The Nora and Valari Residences – Public Comments – Mel Morgan

**RE: Public Comment on the NORA AND VALARI RESIDENCES AT
POULSBO PLACE Project**

Subject: Public Comment on the Nøra & Valari Residences at Poulsbo Place (Project File Number: P-05-26-26-01)

Valari – Use Gray Roof Material

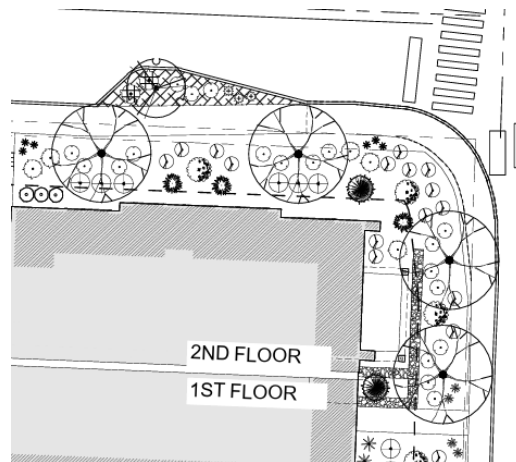
I did not see a specification, but the drawings appear to show a black roof material on Valari. Given that all of Poulsbo Place, the day care center across Sunset from Valari, and almost all of downtown has gray asphalt roof materials, I think using gray roofing material is imperative. This allows differences to be focused on building design and color. Plus, bird droppings are less visible!
